DESIGN REVIEW - 1760 NW 56th STREET

1760 NW 56th St, Seattle, Washington  
DPD Project #3012436

BALLARD INVESTMENT PARTNERS, LLC  
ANKROM MOISAN ASSOCIATED ARCHITECTS  
June 05, 2012

# DEPARTURE #1

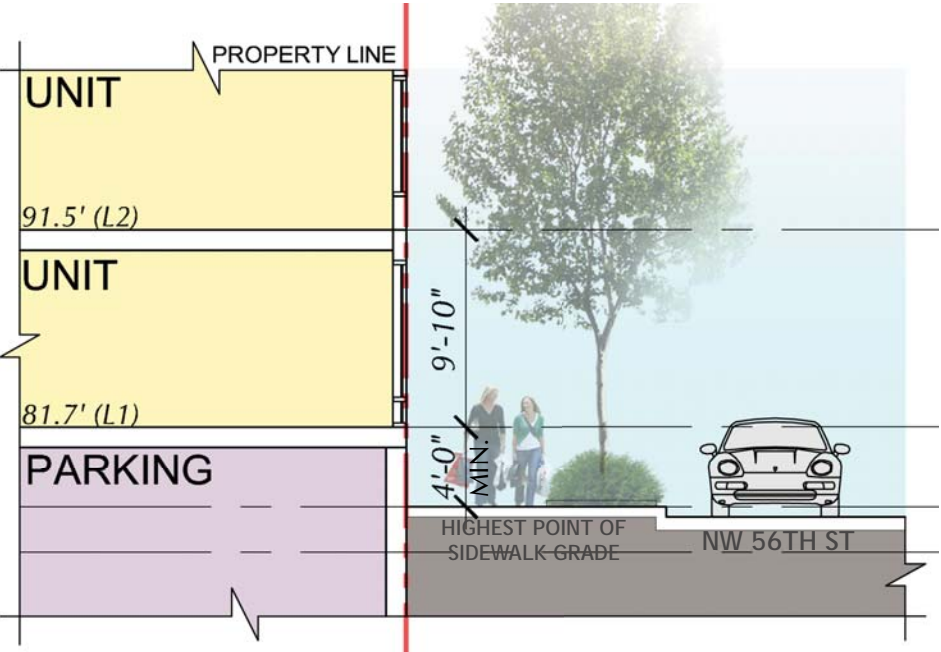
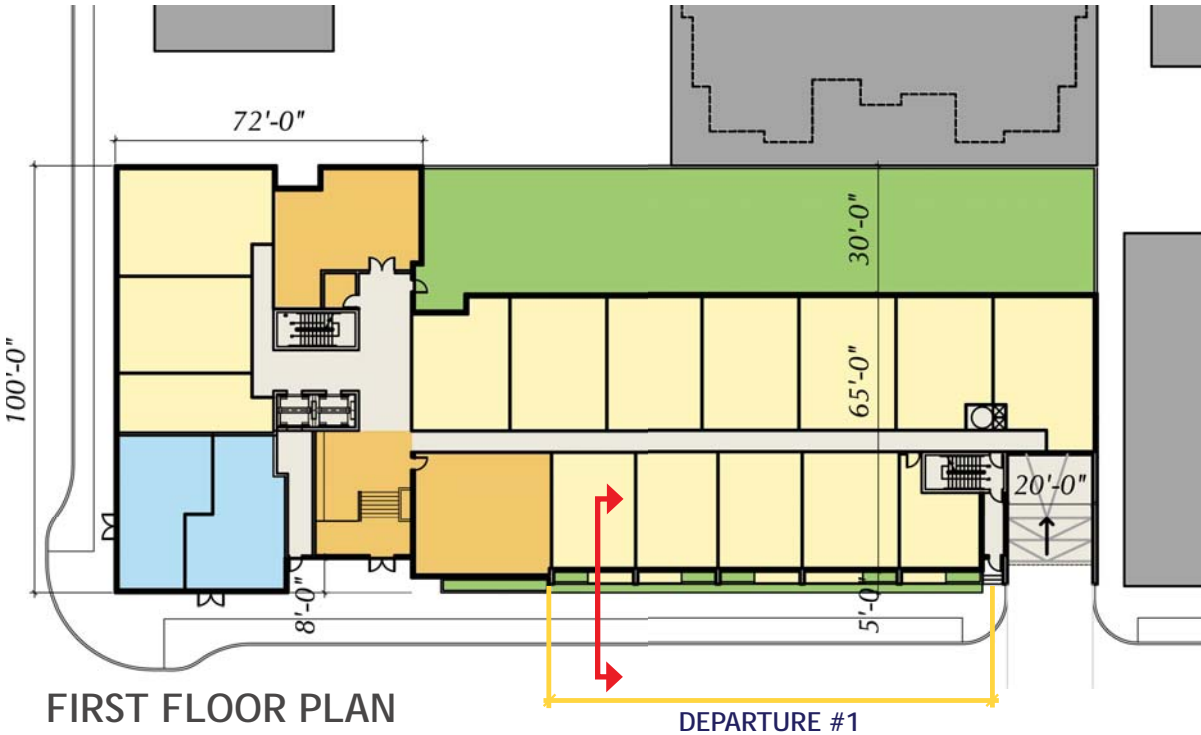
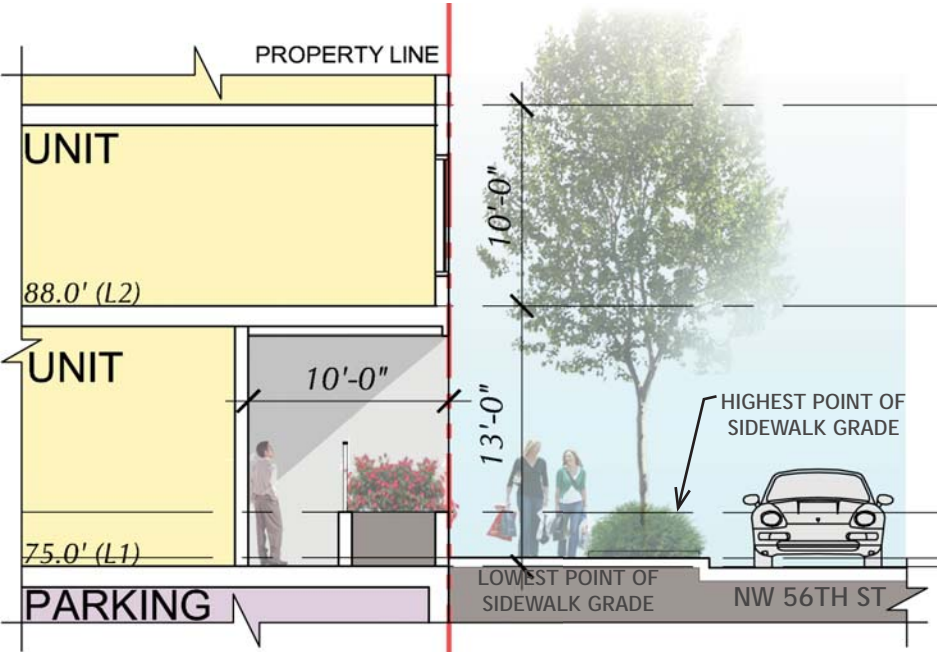
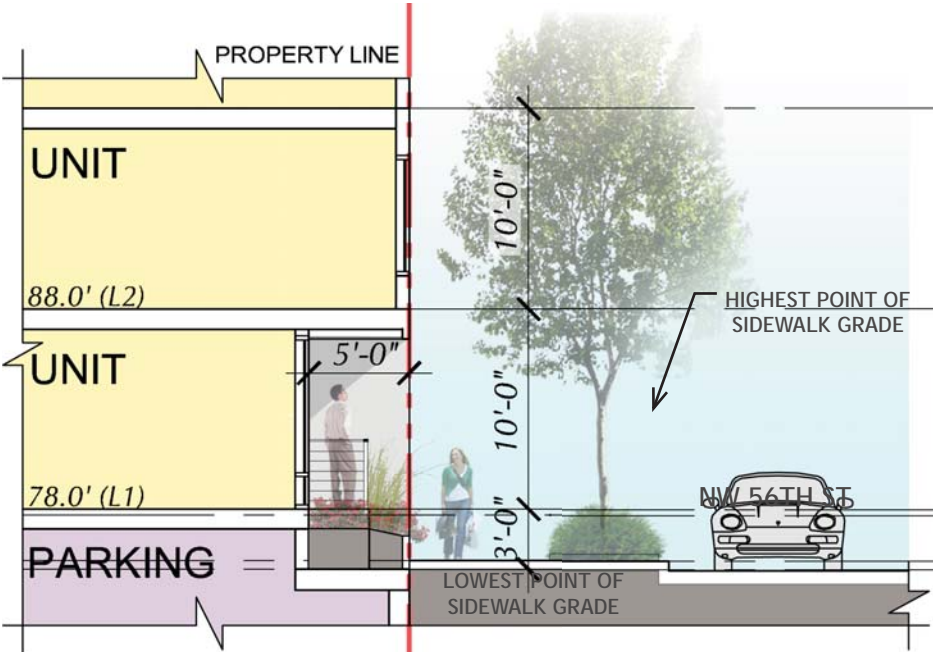
1. Residential Setback on NW 56th Street (SMC 23.47A.008.D): The applicant proposes a five foot setback or a reduction in the vertical distance which would vary from between 1 foot, eight inches (at the SE corner) to four feet (at the SW corner). The board indicated that more information is needed in terms of how these ground level units are designed and integrated with the streetscape along 56th street. The design of the building base, the landscaping and connection to the pedestrian level will be critical considerations in reviewing this departure at the next meeting.

REQUEST	JUSTIFICATION
Requesting a reduction in the horizontal setback for residential use from 10 ft to 5 ft and a reduction in the vertical distance which would vary from 1'-8" (at southeast corner) to 4'-0" (at southwest corner).	Residential use on the ground floor is allowed by code. The proposed solution provides both a horizontal and vertical separation. The sidewalk slopes 2' - 4" so that moving the first floor above the highest sidewalk will both negatively impact all the floor heights above and will potentially create blank walls below the floor slab. The 5' horizontal setback provides a good buffer from the sidewalk with useable outdoor space and landscaping for screening and streetscape enhancement without becoming too deep or creating a weaker urban response.

# DEPARTURE #2

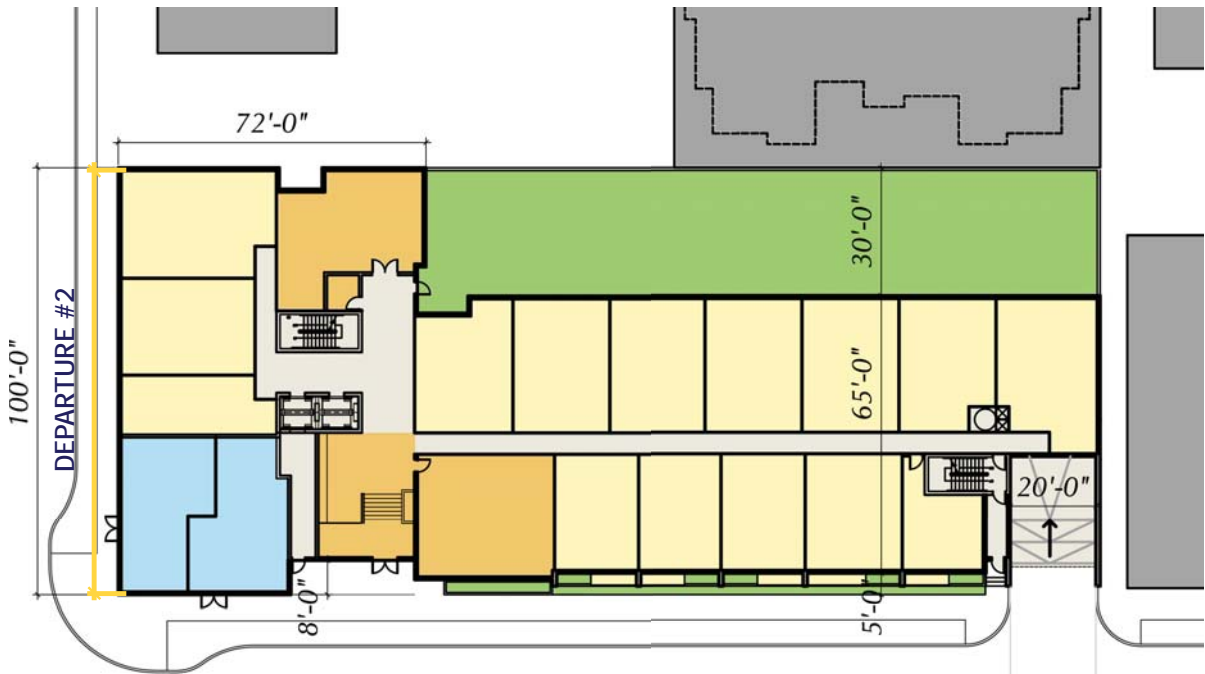
2. Non-Residential Use at Street Level (SMC 23.47A.005.D): The applicant proposes an additional ±43% of residential uses along 20th Avenue NW. The Board indicated a favorable inclination towards such a departure request provided that the taller floor to ceiling height is provided by over-framing the floor and offering greater flexibility for future commercial use conversion along 20th Avenue.

REQUEST	JUSTIFICATION
Requesting an additional ±43% of residential use at street level on this arterial.	Residential has the greatest chance of being leased and active on this façade. Nearby retail space is vacant and this site is beyond the northern edge of Ballard's viable commercial district. Existing commercial spaces currently on-site are vacant. Commercial required at this location will be extremely difficult to finance and lease and current vacancy in this submarket is 23.9%.

# DEPARTURE #3

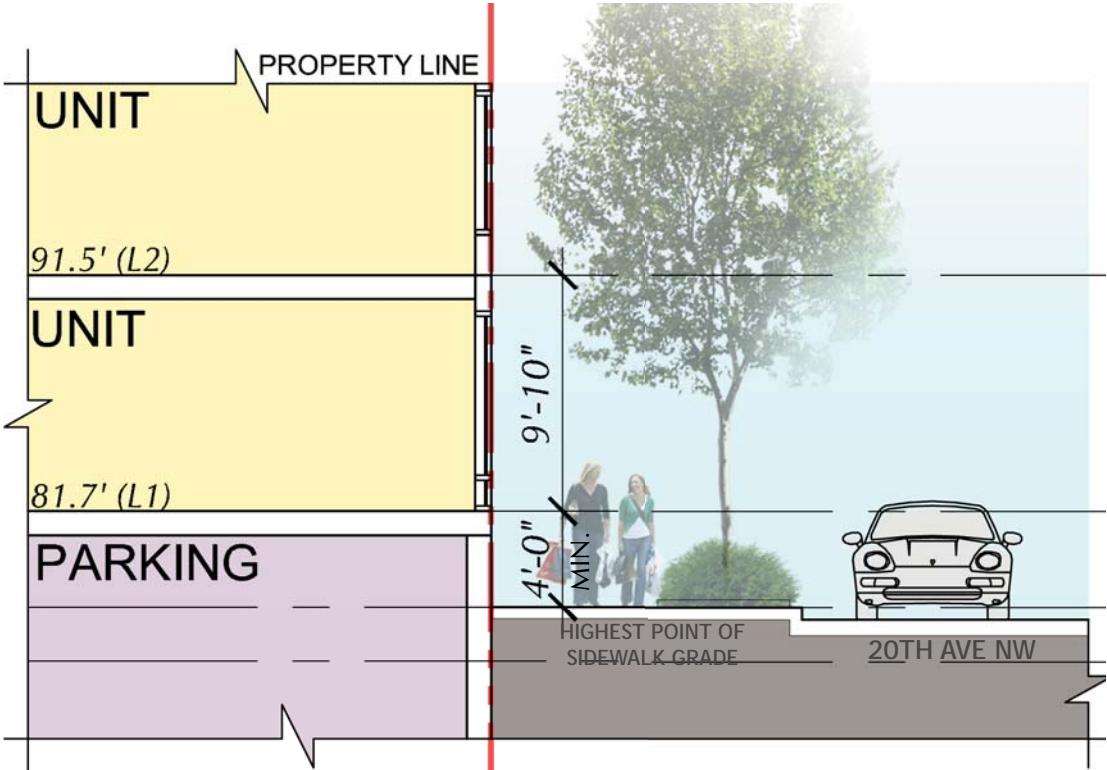
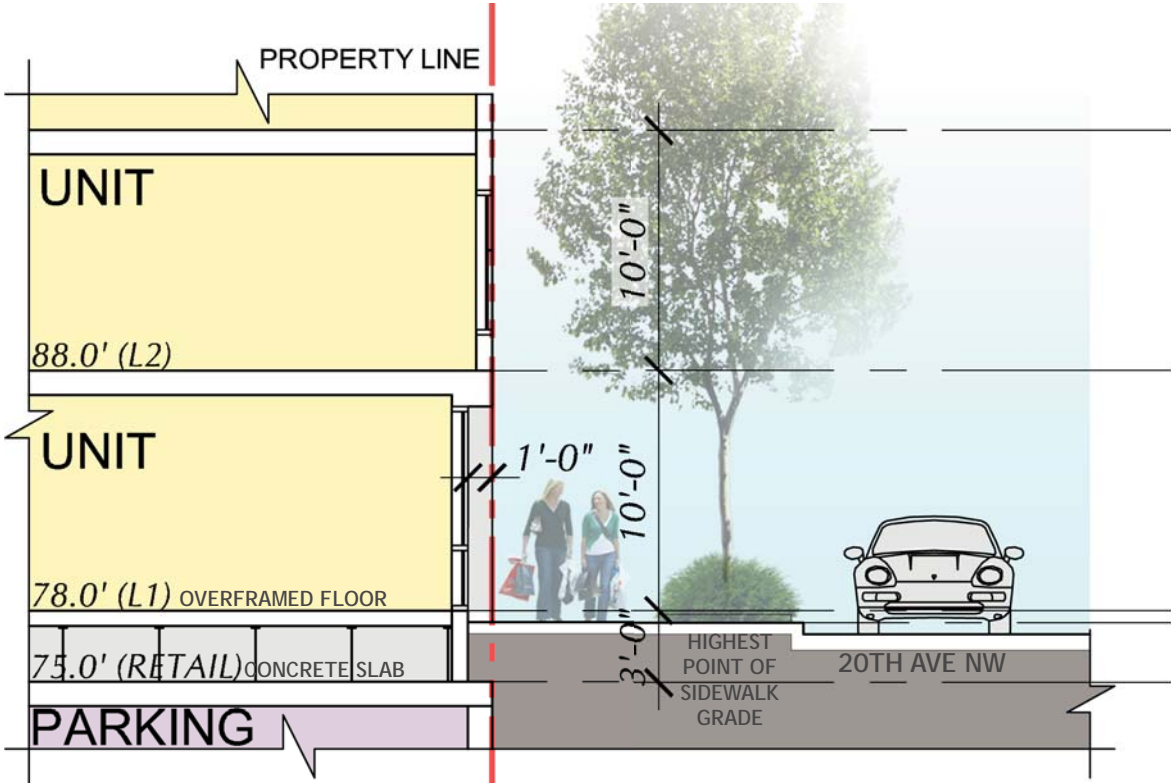
3. Residential Setback on 20th Ave NW (SMC 23.47A.008.D): The applicant proposes no setback along 20th Avenue and a reduction in the vertical distance which would vary from between 1 foot (at the NW corner) and two feet, seven inches (at the SW corner). The Board indicated a favorable inclination towards such a departure request provided that the taller floor to ceiling height is provided by over-framing the floor and offering greater flexibility for future commercial use conversion along 20th Avenue.

REQUEST	JUSTIFICATION
Requesting a reduction in the horizontal set back for residential use from 10 ft to 1 ft and a reduction in the vertical distance which would vary from 1'-0" (at northwest corner) to 2'-7" (at southwest corner).	The proposed solution provides both a horizontal and vertical separation. The sidewalk slopes 1' - 7" along the frontage so that moving the first floor above the highest sidewalk will both negatively impact all the floor heights above and potentially create blank walls below the floor slab. This proposal allows flexibility for future conversion to commercial uses along 20th Ave. NW.
